# Presentation to the ACRS Subcommittee

## Safety Review of the Vogtle Early Site Permit Application

October 24, 2007

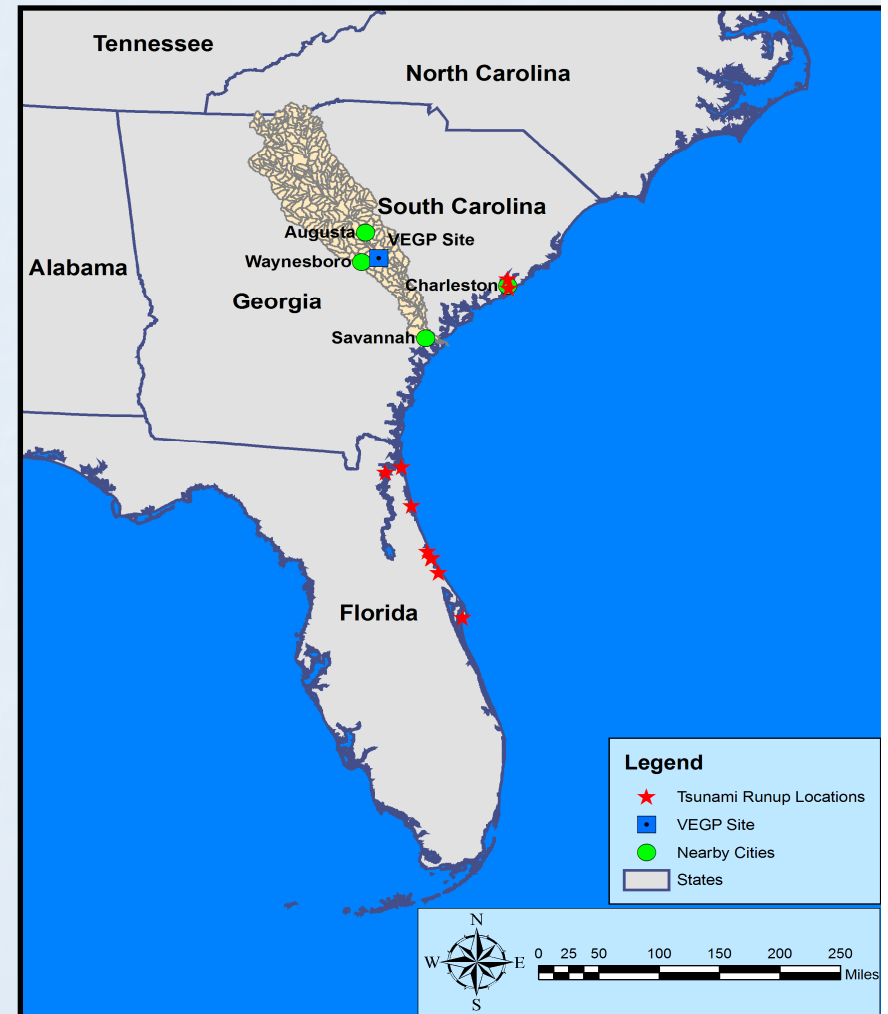
- Section 2.4.13: Accidental Releases of Radioactive Liquid Effluents In Ground And Surface Waters
  - Transport of radioactive liquid effluent is a combinatorial problem with multiple possible environmental pathways – the pathway with the most severe release consequence is of interest for site suitability determination

- Uncertainty due to spatially and temporally varying characteristics
  - Existing hydrology of the site does not necessarily represent the future hydrology; substantial change to the post-construction landscape and hydrologic features may lead to changes in distribution of recharge and the underlying water table and, therefore, changes to the groundwater pathway

- Applicant described a single groundwater pathway to the northwest towards Mallard Pond; staff did not concur with dilution data and release points
  - Staff determined that alternate conceptual models exist that may lead to migration of radioactive liquid effluent (1) to the west and through Daniels Branch, eventually to the southeast and (2) to the east toward the Savannah River through the Tertiary aquifer because of communication between the Water Table and the Tertiary aquifers

- An adequate number of combinations of release locations and feasible pathways has not been considered – **Open Item 2.4-4**

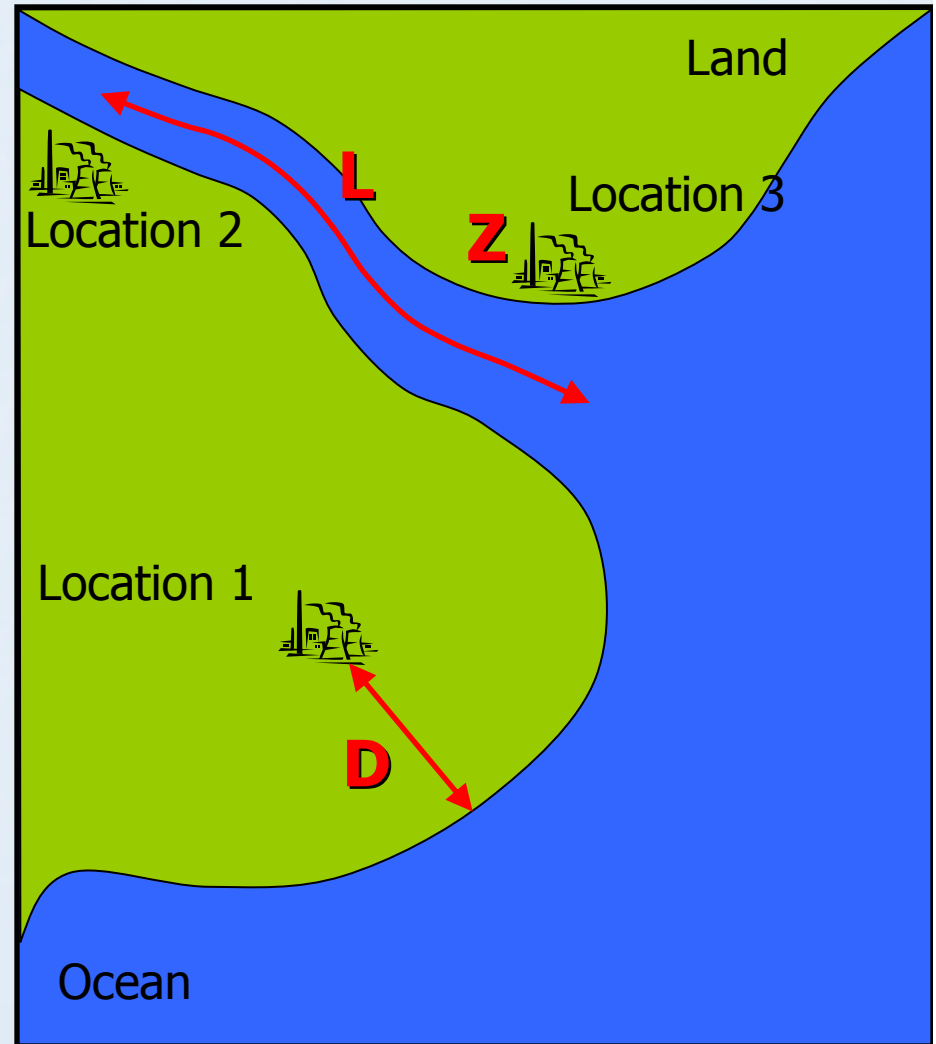
- step 2: site screening
  - The DLZ rule
    - D: horizontal distance,  
L: longitudinal distance  
along river or stream  
from estuary, and  
Z: elevation of the site
  - The Vogle ESP site: 100 mi inland  
from the coast, approximately 150  
river miles from the estuary, and at  
an elevation of 220 ft MSL
  - A tsunami would need to inundate  
100 mi inland and run up to 220 ft  
MSL, and a tidal bore would need  
to travel 150 mi upstream and  
reach 220 ft MSL
  - In US, tidal bores occur in Cook  
Inlet, Alaska
- step 3: comprehensive THA
  - Not needed
